Site Development Checksheet Response

Permit #: 08-122284-EXC-01-CO

1st Site Development Check Sheet Response

To respond to this checksheet, bring to Document Services, 1900 SW 4th, a complete set of updated plans: one set for each checksheet. However, a single set may be submitted for responses to Fire, Life Safety, Structural and Site Development checksheets. You will also need to update or replace the Reference set kept in Document Services. Provide with your submittal, the attached Checksheet Response form.

5 TYPICAL SOIL NAIL WALL & HEAD DETAIL

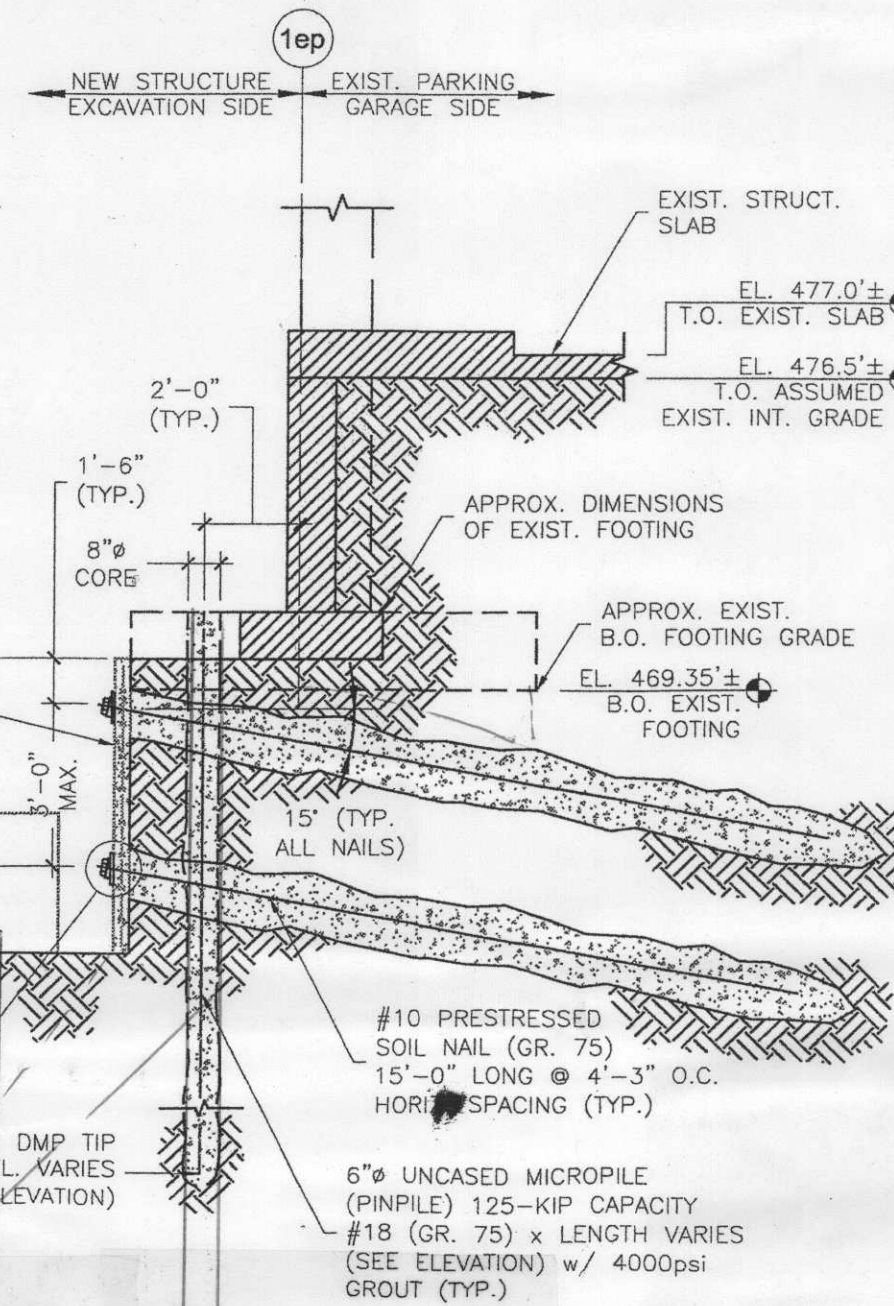
27.		106.1.1	New Comment (August 8, 2008) In the pin pile/rock anchor drawings, is a drawing ES2 intended to be present? If so, it is missing from the submitted set of drawings.

Further, GZA Figure ES2 is being revised to clarify the construction sequence for the temporary soil nail wall construction. Drawing ES2 will be submitted under separate cover.

Please refer to attached drawing ES2 which has been revised to address the necessary modifications. Please contact Steve Spencer at 425-898-0210 with any questions or comments that you may have.

- Items 3 – 26 To be addressed by others.
- 27 GZA Drawing ES2 is included in this submittal. It was previously submitted under separate cover
- 28 Design of the permanent Drilled Piers was prepared and detailed by the Project Structural Engineer.
- 29 Design of the CIP concrete foundation elements (pile caps, grade beams, structural slabs, etc) was prepared and detailed by the Project Structural Engineer.

A317

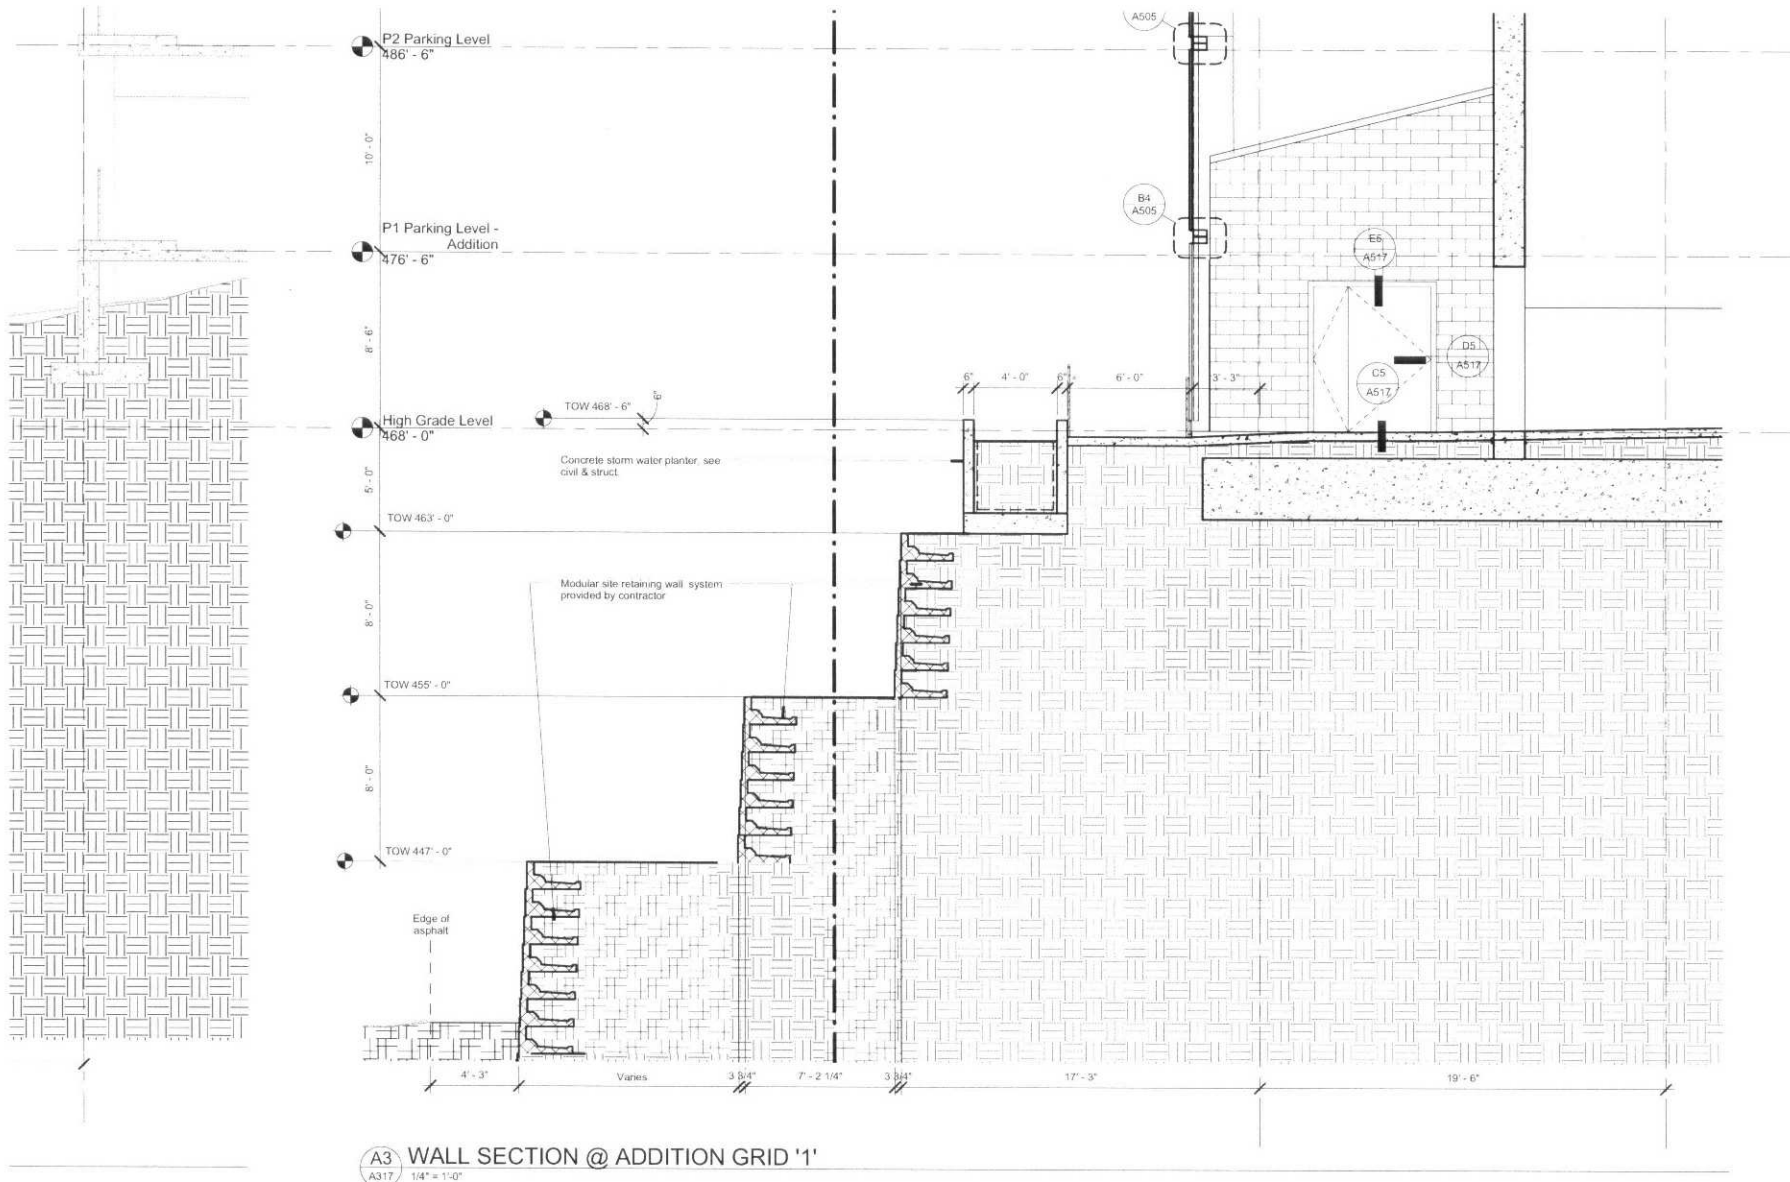
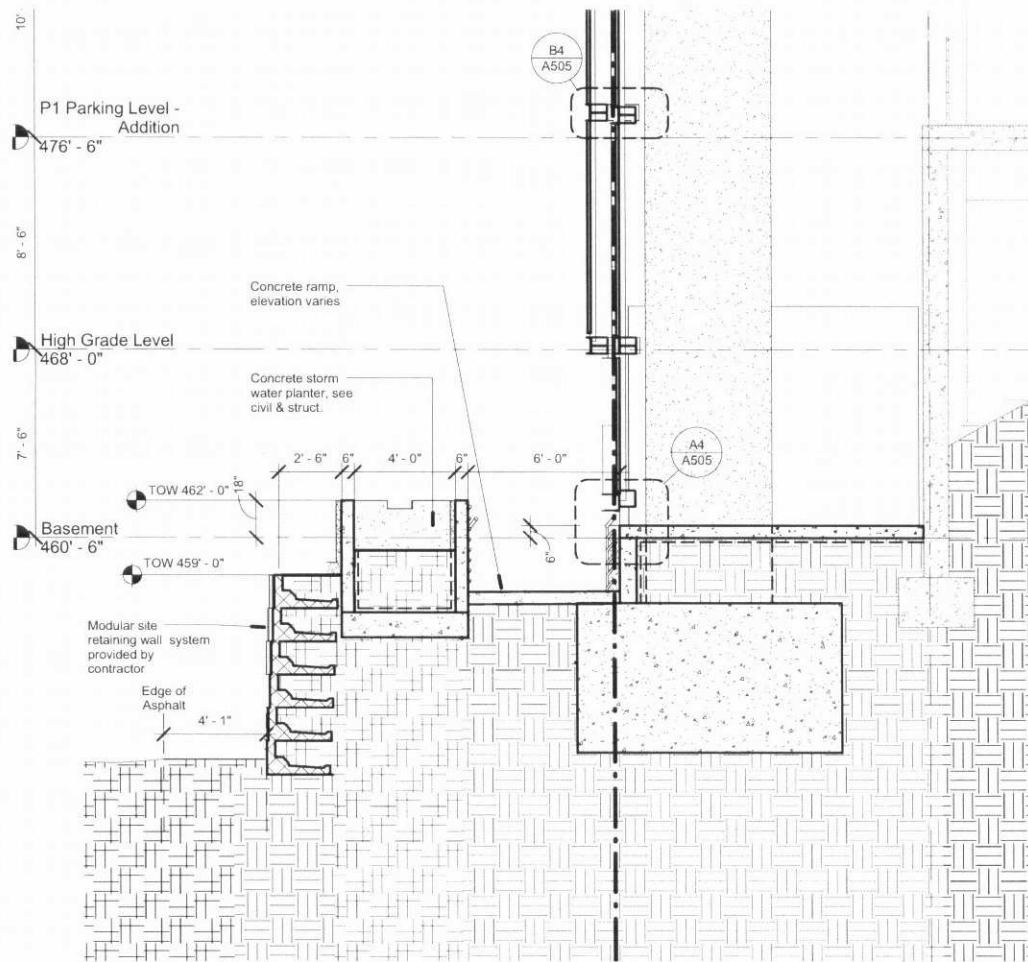
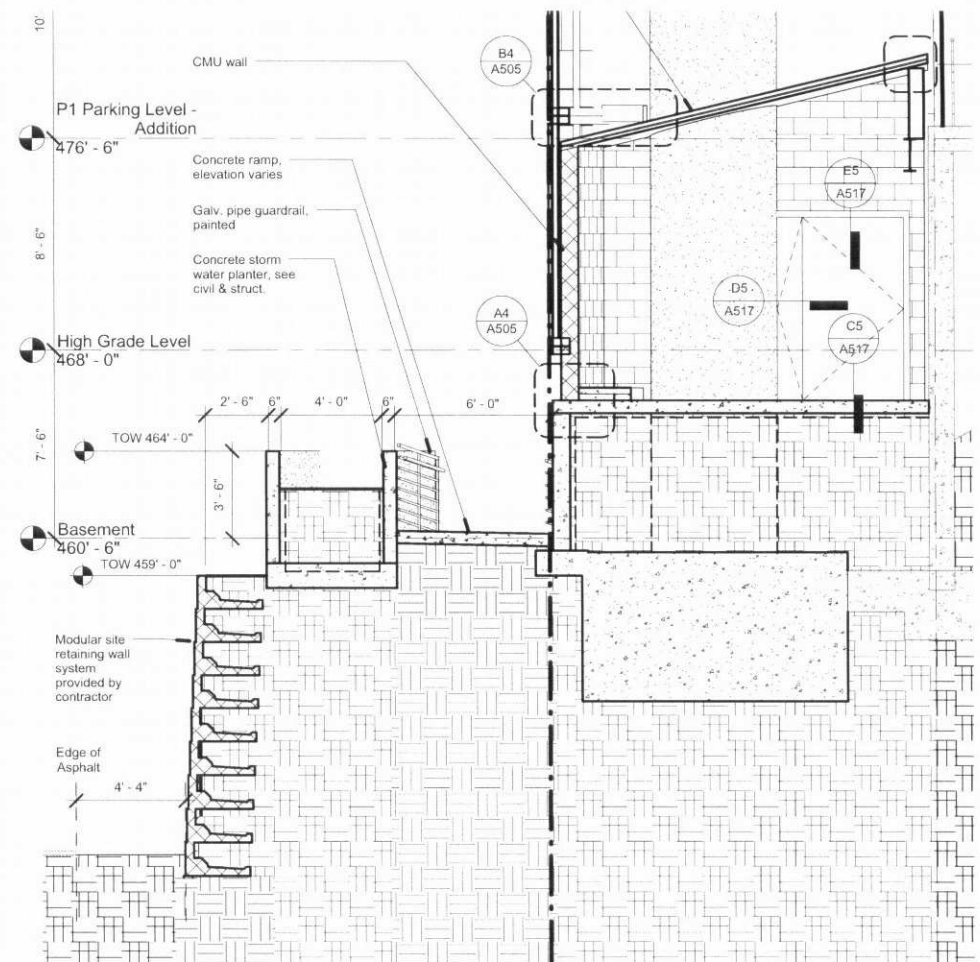
2 cont- inued	Sheet A317	Malcom	b. In accordance with section 1808.2.4 of the Oregon Structural Specialty Code, no vertical load can be assumed to be carried by soil beneath pile caps. Likewise, no vertical load should be assumed to be carried by spread footings or grade beams between pile caps. Please revise or clarify.
		Malcom	c. Soil nail walls are flexible structures and some soil movement is expected prior to load transfer to the nails. Wall flexure will result in some soil movement behind the wall. Soil movement behind the wall may cause settlement of the west side of column footings as well as soil underlying the spread footings. Please demonstrate that the proposed micropiles can withstand the additional loading and moments due to structural load transfer after soil movement behind the soil nail wall.
		PCC / Malcom	d. The temporary cut for construction of the Lock + Load wall remains within the influence zone of the existing structural spread footing load and west portion of the existing structural column loads. Please demonstrate how the stability of the parking garage will be maintained during construction of the retaining walls.

3	Retaining Wall Calcs/ Geotech Report Sheet A317	OSSC 1610.1 1613.1 1802.2.7	<p>The structural and architectural plans indicate a shallow foundation supporting the one story generator rooms will partially overlie the geogrid reinforced zone and roughly 20 to 25 feet of engineered fill. Presumably, the generators are back-up generators servicing the hospital in case power of an outage such as may be expected following a design seismic event. Please address the following:</p> <ul style="list-style-type: none"> A. Include the shallow foundation, slab, and generator dead load in the slope and wall stability calculations. B. Provide an addendum from the project geotechnical engineer recommending a horizontal acceleration for use in design of the slope/wall configuration supporting the generators. Revise the wall and slope calculations as necessary. C. Provide calculations estimating the static settlement between the fill supported shallow foundation and the pier supported primary foundation. D. Provide calculations estimating the anticipated permanent displacement of the shallow foundation and generators during a seismic event. E. Demonstrate that the generators will operate after undergoing the estimated displacement following the design seismic event. This may involve the expertise of the project electrical, mechanical, structural engineers, or others. <p>Please note that if the generator room foundation plan is altered to include drilled pier support, consideration should be given to the constructability of the piers through the geogrid reinforced zone.</p>
